1 March 2018

Our Ref: NP/PTR/Circular/2018/02

## **REVISION TO PLANTING AREA PROVISION REQUIREMENTS WITHIN PREMISES**

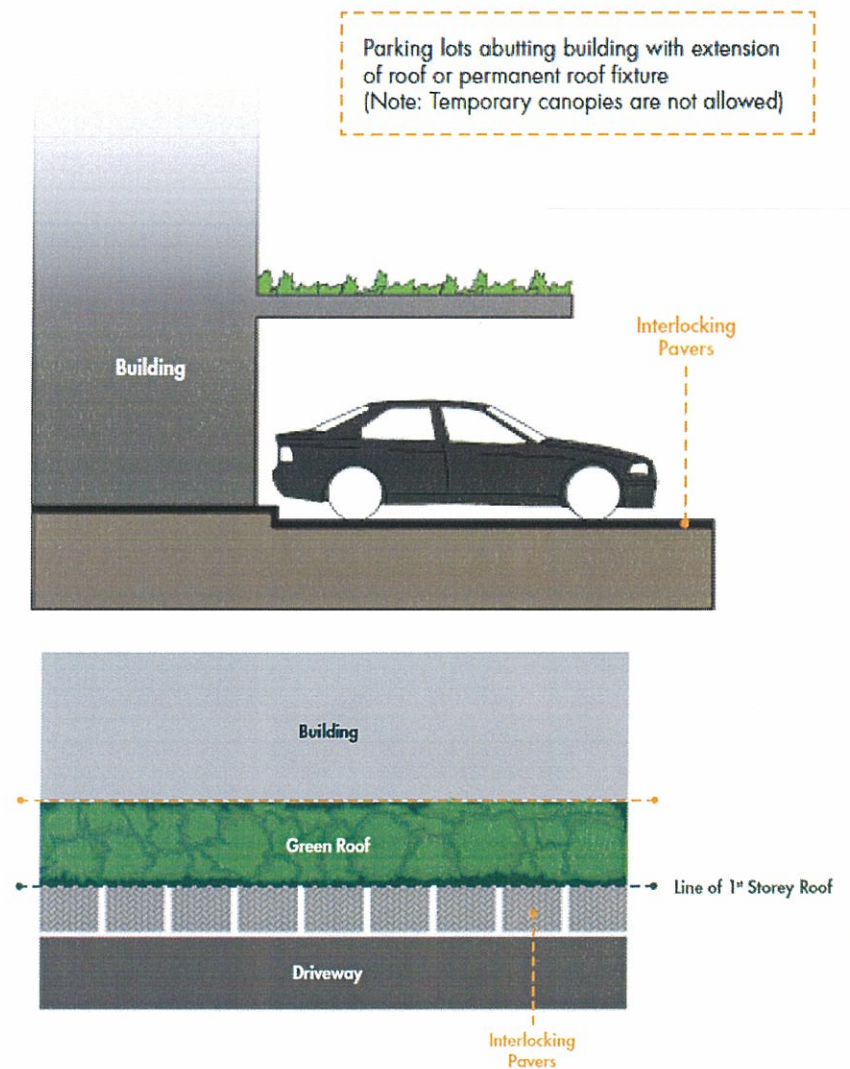
2 Currently, green buffer is provided along the front boundary of premises adjoining or abutting a public road at a uniform width of 3.0m or 5.0m.

3 Moving forward, there can be varying width of green buffer (minimum 2.0m), while keeping the total area of the green buffer along each side of the premises unchanged. The total area is calculated based on current guideline of 3.0m or 5.0m width multiplied by the length of the green buffer for that side of the premises.

Parameter	Details and Examples
-----------	----------------------

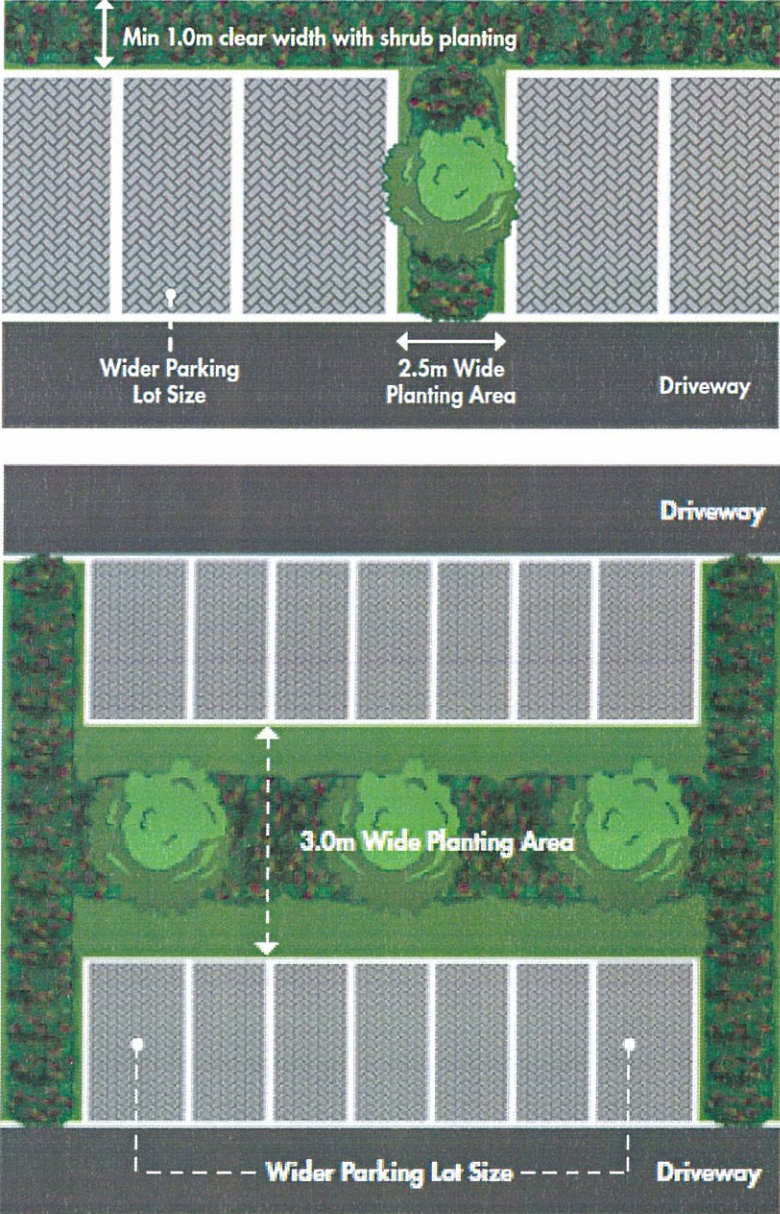
- All planting areas should have a minimum 1.0m clear width, except for those planting areas designated for tree planting must have a minimum 2.0m clear width

- Configuration of the planting area must allow for trees to be planted at a maximum spacing of two lots' length for parallel parking

- For parking area directly adjacent to a building, where there are shelters affixed directly to the building and cover
